AMERICANS WITH DISABILITIES ACT SELF EVALUATION AND TRANSITION PLAN

**MOORESTOWN TOWNSHIP
BURLINGTON COUNTY, NEW JERSEY**

March 18, 2020

BUILDING:
Moorestown Town Hall
LOCATION:
111 West 2nd Street

TH.29

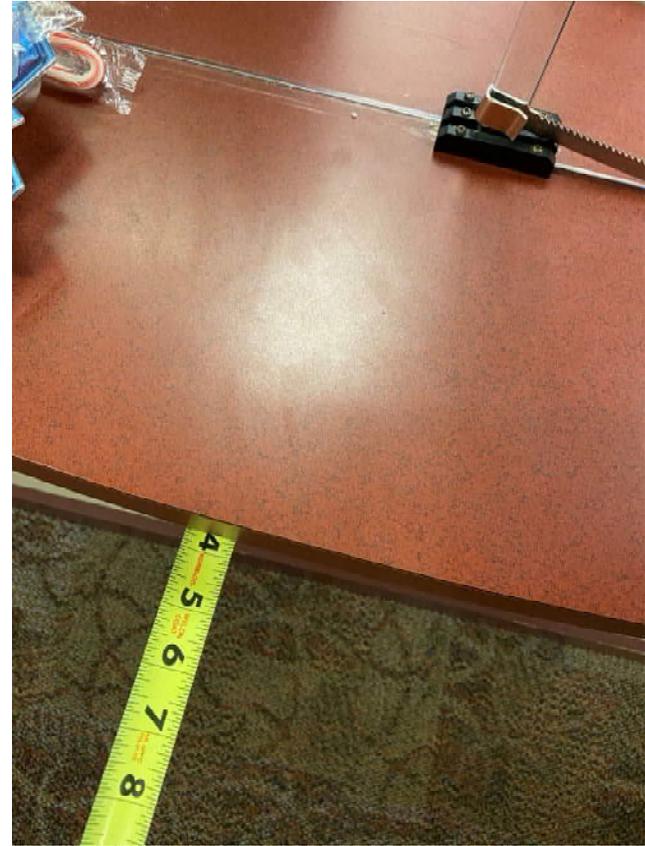
3.119	Is the door self-closing?	<input type="checkbox"/> Yes <input checked="" type="checkbox"/> No	Photo # TH.21	Both 1st and 2nd floor accessible toilet compartment doors are not self-closing Add closer or replace door with a self closing door

MC.4

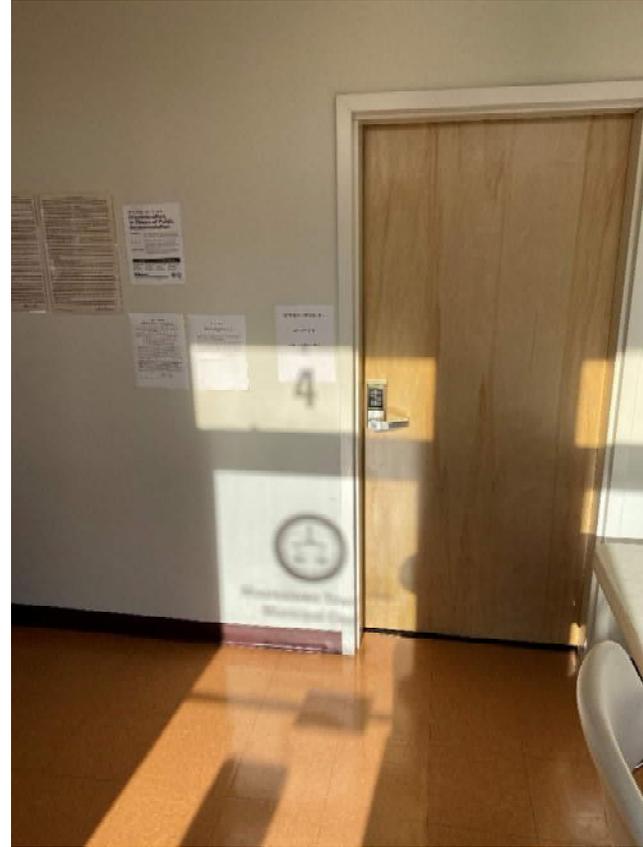
Comments	Possible Solution	
ROOM SIGNAGE				
2.53	Are there signs designating permanent rooms and spaces not likely to change over time?	<input type="checkbox"/> Yes <input checked="" type="checkbox"/> No	Photo # MC.4 The public only has access to the main lobby. In the lobby there is no signage designating the room accessed from the main lobby. There is a paper sign stating that the door is for employees only	Replace paper sign with a permanent sign in accordance with the code.

2.54	Do the signs have raised character and Braille?	<input type="checkbox"/> Yes <input checked="" type="checkbox"/> No	Photo # MC.4	Provide sign with raised characters and Braille

2.55	Do the text characters contrast with the background (i.e. dark characters on a light background or vice versa)	<input type="checkbox"/> Yes <input checked="" type="checkbox"/> No	Photo # MC.4	Provide sign with text characters that contrast with the background.

MC.9

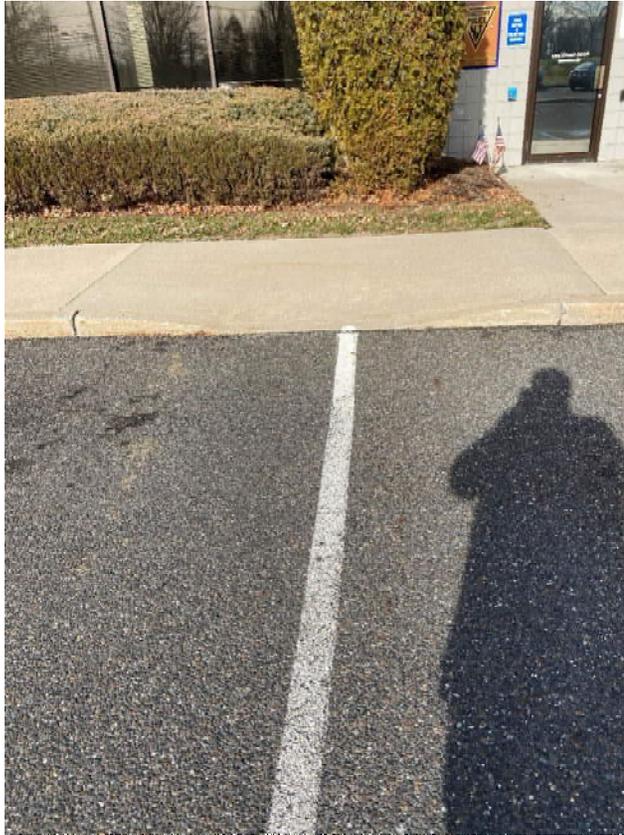
1.22	Is the running slope of the curb ramp 1:12 or less?	<input type="checkbox"/> Yes <input checked="" type="checkbox"/> No	Photo # MC.9
			The slope of the curb ramp 1.25" per 12"
			Replace the curb ramp with a ramp with a 1:12 or less slope.

PD.2

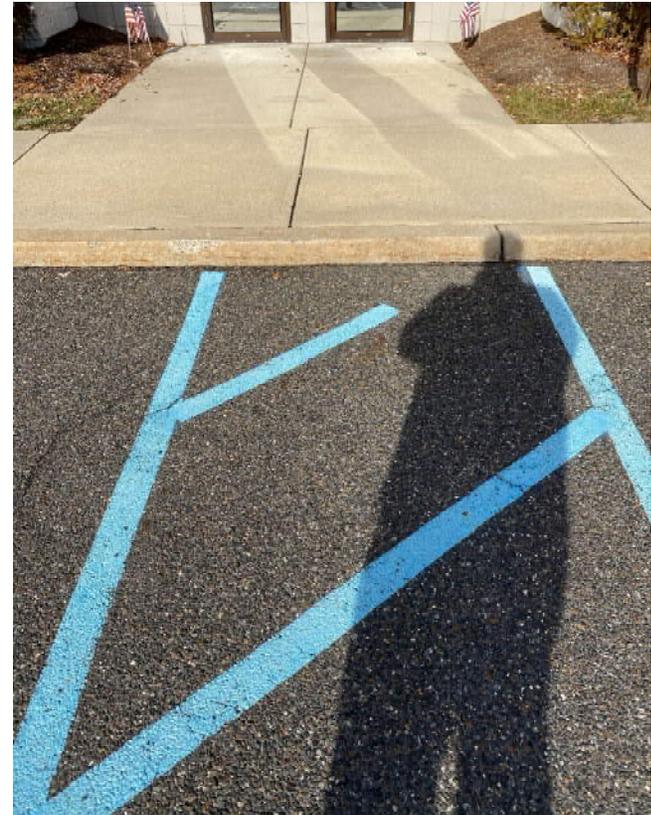
1.9	Does the aisle access adjoin an accessible route?	<input type="checkbox"/> Yes <input checked="" type="checkbox"/> No	Photo # PD.2	The curb ramp is not located at the end of the access aisle. Therefore it does not have access to the accessible route.	Option 1: restrip the parking spaces so the accessible access aisle is at the curb ramp. Option 2: Remove existing curb ramp and provide a new curb ramp at the access aisle

PD.10

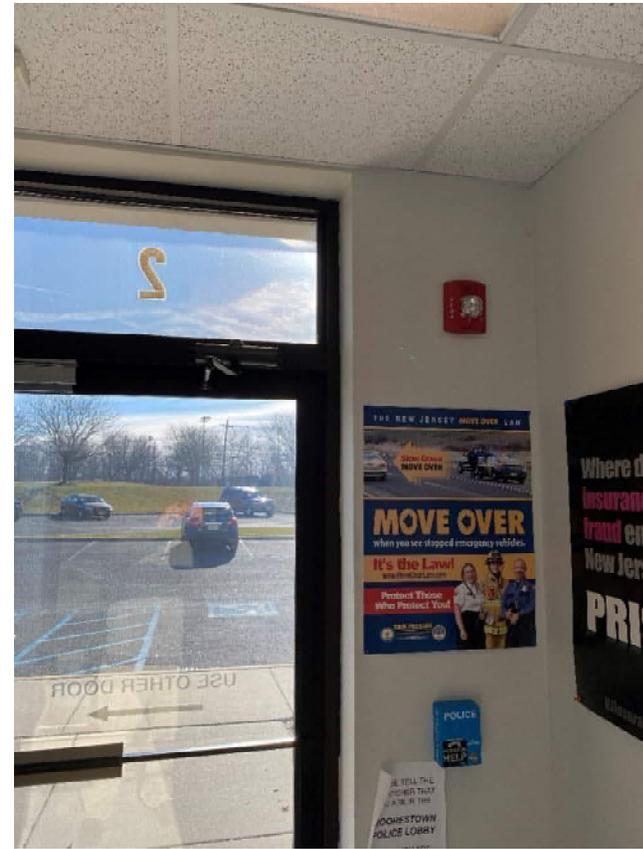
Comments	Possible Solution
ROOM SIGNAGE			
2.53	Are there signs designating permanent rooms and spaces not likely to change over time?	<input type="checkbox"/> Yes <input checked="" type="checkbox"/> No Photo # PD.7, PD.8, PD.9, PD.10 & PD.11	The public has access to the main lobby and one interview room. In the lobby there is no signage designating the room accessed from the main lobby.

2.54	Do the signs have raised character and Braille?	<input type="checkbox"/> Yes <input checked="" type="checkbox"/> No Photo # PD.7, PD.8, PD.9, PD.10 & PD.11	Provide sign with raised characters and Braille

2.55	Do the text characters contrast with the background (i.e. dark characters on a light background or vice versa)	<input type="checkbox"/> Yes <input checked="" type="checkbox"/> No Photo # PD.7, PD.8, PD.9, PD.10 & PD.11	Provide sign with text characters that contrast with the background.

PD.17

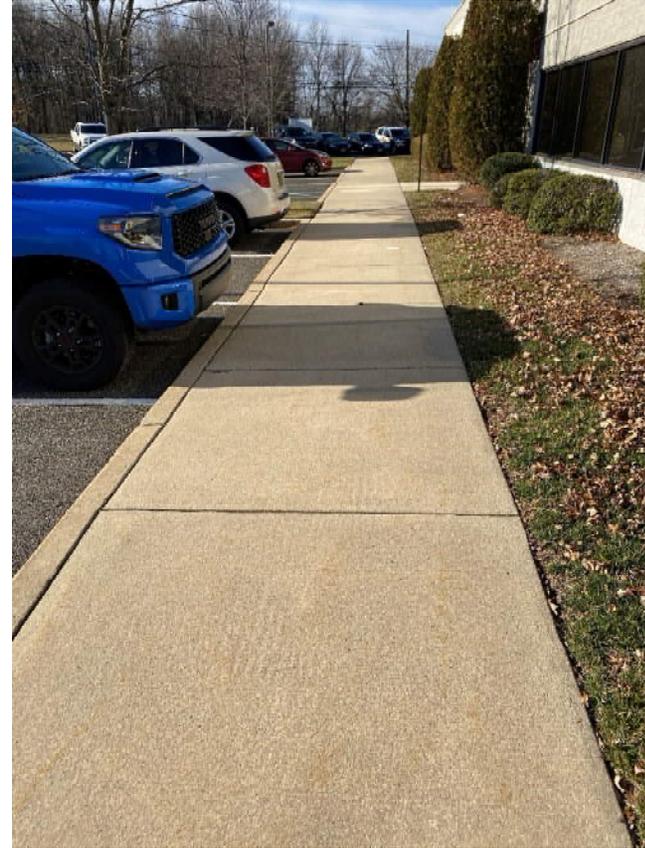
4.26	Is there a clear floor space postioned for parrallel approach to an end of the bench?	<input type="checkbox"/> Yes <input checked="" type="checkbox"/> No	Photo # PD.16 & PD.17	There is not a clear floor space on the end of the bench.	Provide a 30 inch by 48 inch clear floor space on one end of the bench

4.30	Are no fewer than one water closet, one lavatory, and one bathtub or shower accessible?	<input type="checkbox"/> Yes <input checked="" type="checkbox"/> No	Photo # PD.16 & PD.17	The toilet and lavatory are not accessible.	Provide accessible toilet and lavatory in accessible cell.

CS.44

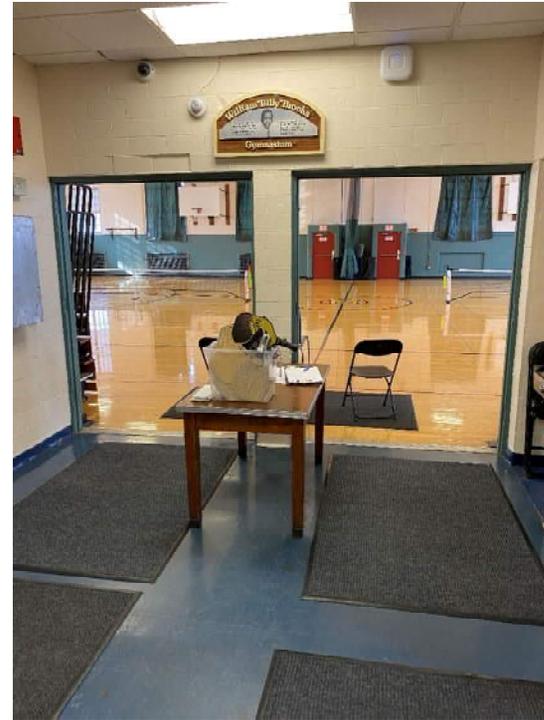
Comments	Possible Solution
ROOM SIGNAGE			
2.53	Are there signs designating permanent rooms and spaces not likely to change over time?	<input type="checkbox"/> Yes <input checked="" type="checkbox"/> No	Photo # CS.44 No signage at permanent rooms and spaces not likely to change over time.

NA.1

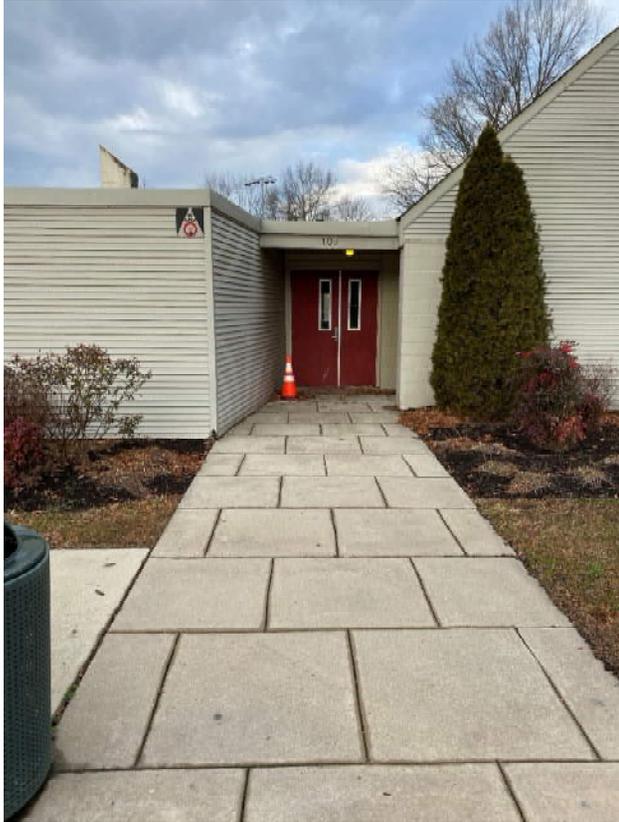
1.49	If not all entrances are accessible, is the accessible entrance clearly marked with a sign with the International Symbol of Accessibility?	<input type="checkbox"/> Yes <input checked="" type="checkbox"/> No	photo # NA.1 The main entrance is the only entrance the public uses. There is no accessible signage provided.	Provide signage

NA.3

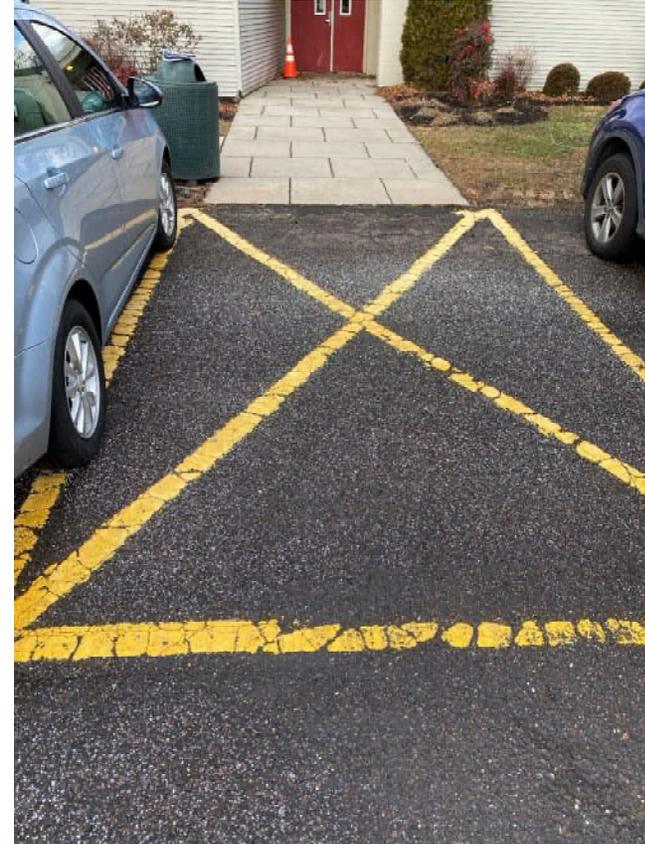
1.12	Is the van accessible parking spot clearly marked with proper signage?	<input type="checkbox"/> Yes <input checked="" type="checkbox"/> No	photo # NA.3	There are no van accessible spaces provided	Provide proper signage at required van accessible parking space
